Leigh Anne and Phil Francis
Comments on Path on the West Side of the south bound Main Bridge

View East from
Local Harbor
Bridge

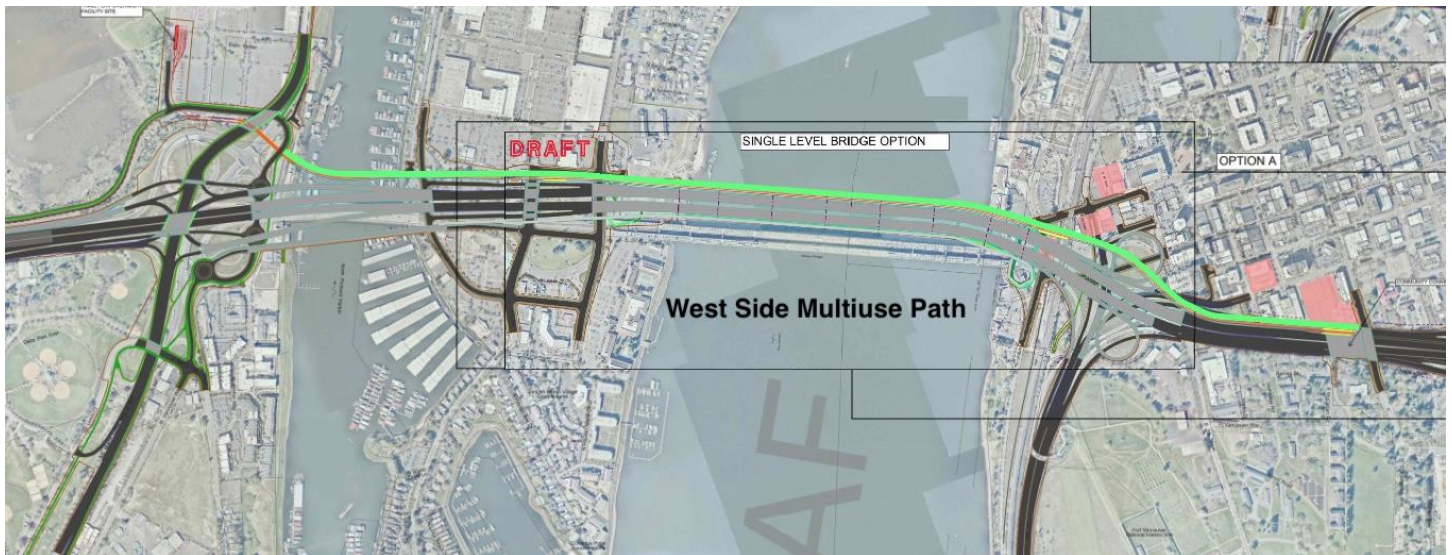
Regarding Views: There is a good view of Mt Hood if the multiuse path is on the east side of the north bound main bridge, however there is a good view to the west too. Additionally, a quality view of North Portland Harbor and Mt Hood views could be experienced on the local harbor bridge, but the IBR proposes the multiuse path on the west side of that local Harbor Bridge. The IBR also shows a side walk on the east side of the local Harbor Bridge. We propose that the side walk on the east side of the Local Harbor Bridge be as wide as possible and include wide spots for stopping on the route to rest and appreciate one of the region's best view of North Portland Harbor.
